Revised plan for extension: 27 Sheraton Drive Kidderminster DY103QR

Submitted by C F Hancox. February 16th 2024. Address as above. Tel: 01562 753905.

The fourth, (Drawing No. 02/24/a) shows the proposed amended front elevation, the sixth (Drawing No 02/24/b) shows the proposed amended extension plan, the seventh (Drawing No. 02/24/c) the proposed amended roof plan and the eighth (Drawing No. 02/24/d) the proposed amended foundation layout.

Drawing No. 02/24/a

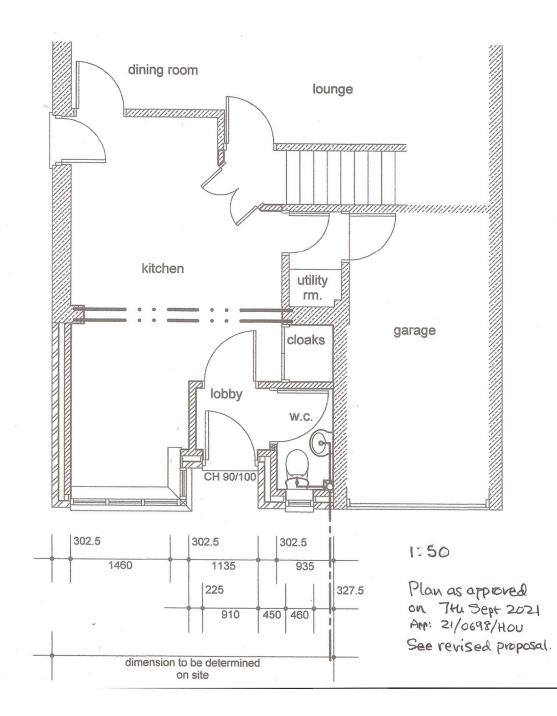
Proposed amended front elevation 1:50 February 6th 2024

Proposed south elevation amendment. Scale 1:50

Proposed amended plan. Scale 1:50 Drawing No 02/24/b

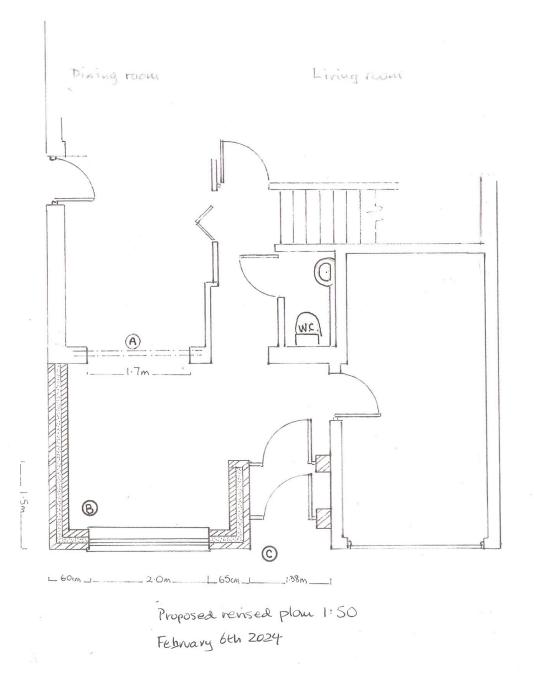
The revised plan remains on exactly the same footprint as at that of 7th Sept 2021. However no structural alterations other than the opening in place of the kitchen window would be carried out to the existing house.

Revised noof layout proposal 6th February 2024.

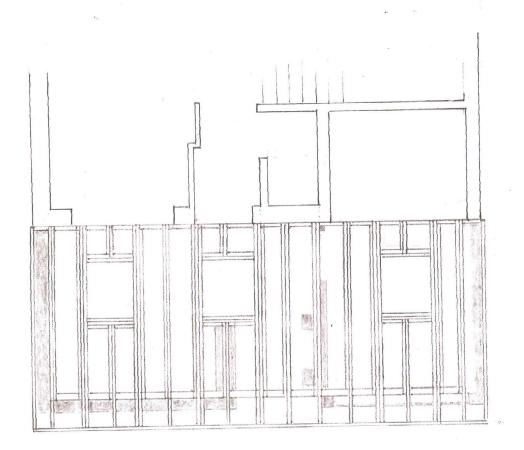
At point (A) the existing window aperture is opened out by 25cm on each side to provide a 1.7m walk through. At point (B) the window does not start immediately at the side wall. This provides 0.6m of wall at the front of the house on the west side of the window, providing strength and avoiding the need for a wind post. At point (C) the front door is positioned around 1.0m to the right of that shown on the south elevation of that approved on Sept 7th 2021. This also provides supporting wall between the window and the doorway.
